**From:** Vij, Rohit  
**Sent:** Monday, April 16, 2018 3:27 PM  
**To:** Moyer, Laurie  
**Subject:** RE: SMTX Transportation Masterplan Comments

To the San Marcos Engineering Department:

# Transportation Master Plan Cross-Sections

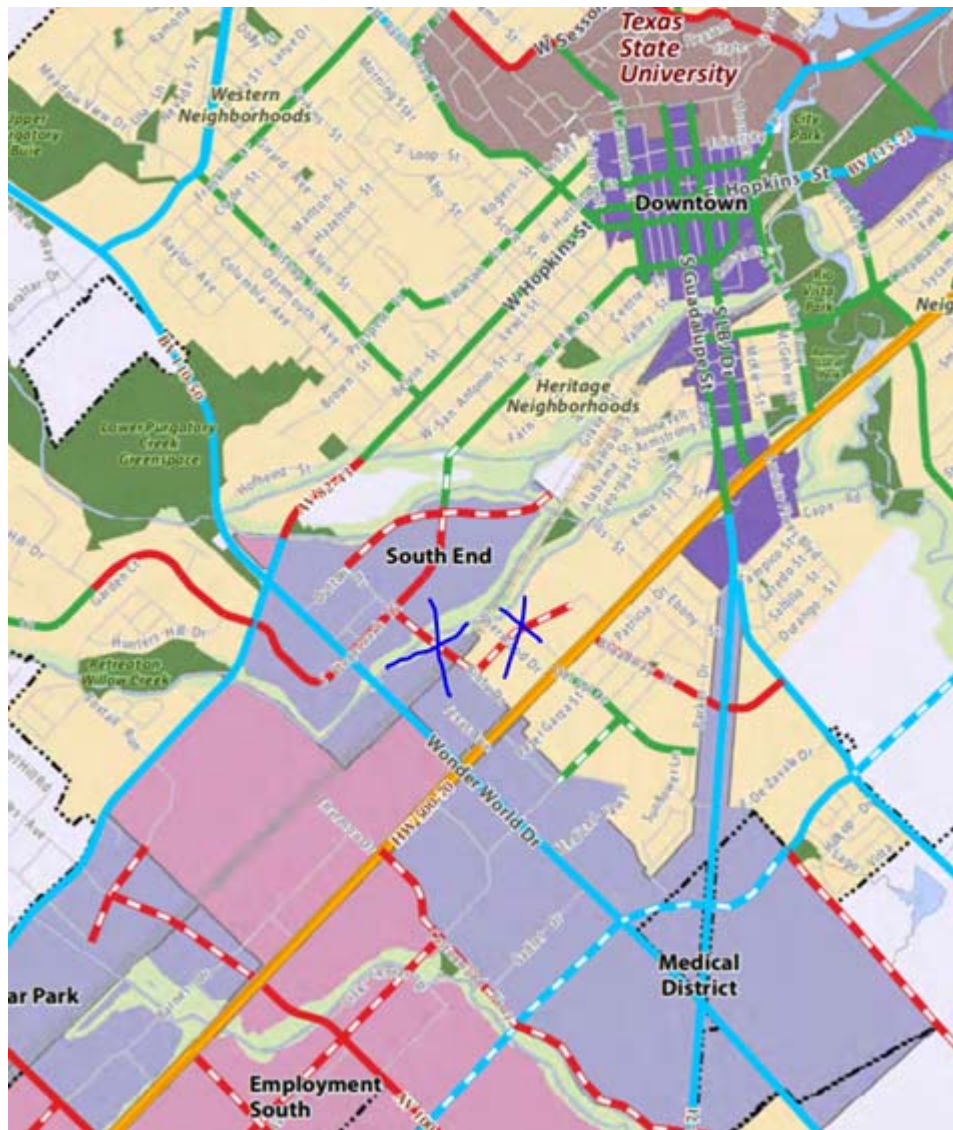
2. In reviewing the open house presentation, the TMP cross sections for inner city streets (boulevards through residential streets) list lane widths that do not align with the street types in CodeSMTX or current planning policy surrounding vehicular movement in cities, which is to slow cars down to encourage safer streets for not only other cars but pedestrians and bikers. 11' lane widths and greater have been found to cause greater crash rates and higher impact speeds and the National Association of Transportation Officials (NACTO) states that 10' lane widths are appropriate in urban areas (versus the 11' - 13' lane widths that have historically been used in cities and are currently listed on the TMP cross-sections presentation, screen shot below). 10' lane widths have a positive impact on the safety of streets for other cars as well as pedestrians and bikers, particularly when speeds are 35 mph and below. **I strongly encourage the City to revise these proposed cross sections to reflect the goals of walkability embedded in CodeSMTX as well as make San Marcos a safer place for all modes of traffic.**

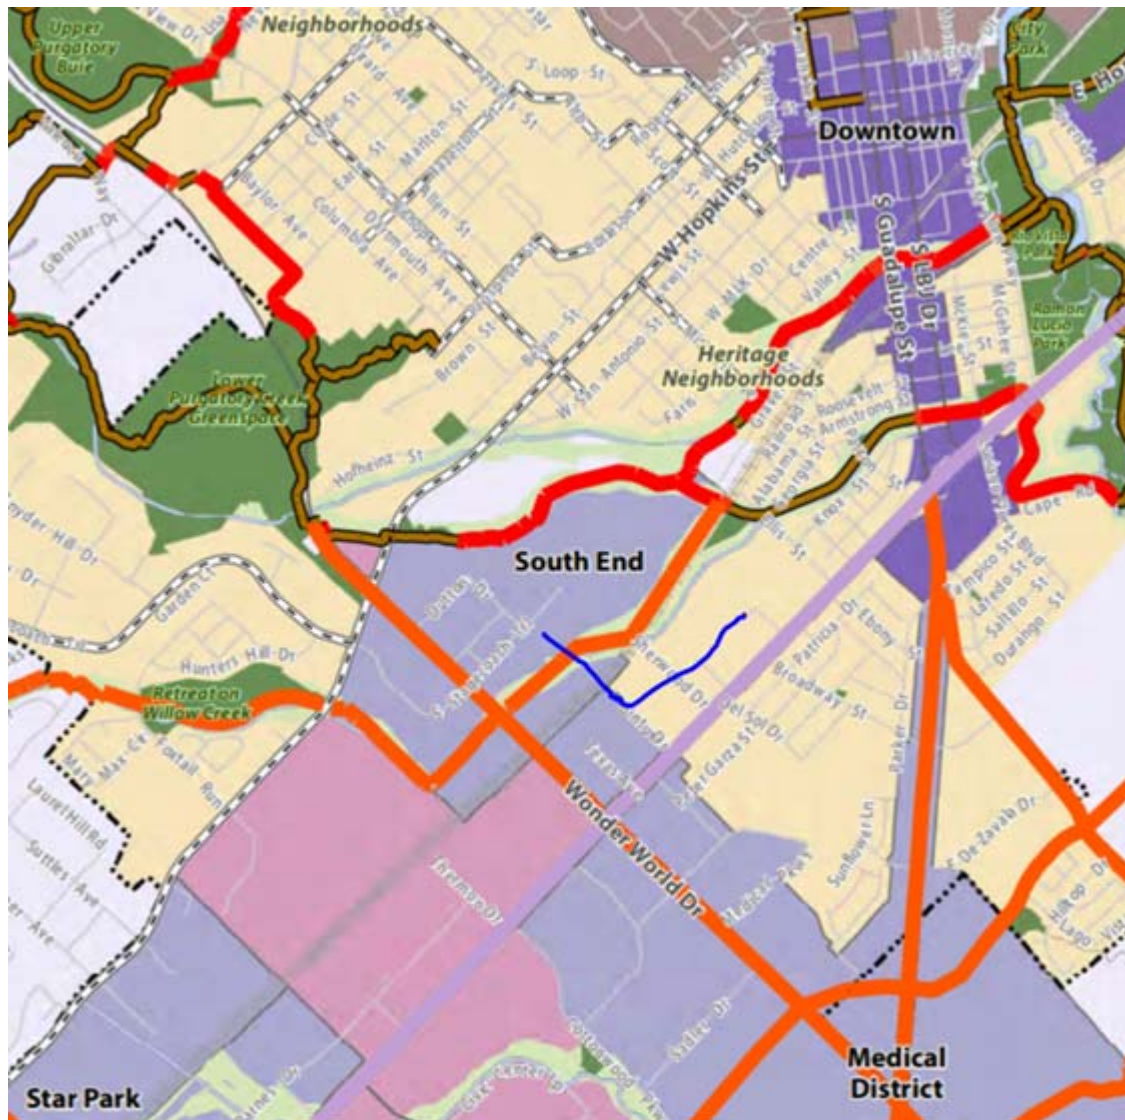
3. In the South End, I do not recommend placing an avenue along Purgatory creek, which includes more sensitive riparian areas that flow to the San Marcos river. The southeastern part of the route appears to go through an existing detention area, as well. Emphasizing the cross connection between Gravel road and Dutton Drive takes away from the prioritization and importance of the Stagecoach Trail to MLK connection. The new CodeSMTX would allow for a more defined road network that is sensitive to the site constraints and any Gravel street connection would be better indicated as a pedestrian and cycling trail crossing - not a vehicular thoroughfare - to indicate more sensitive traffic parallel to the creek network. Screenshot below of this suggestion below.
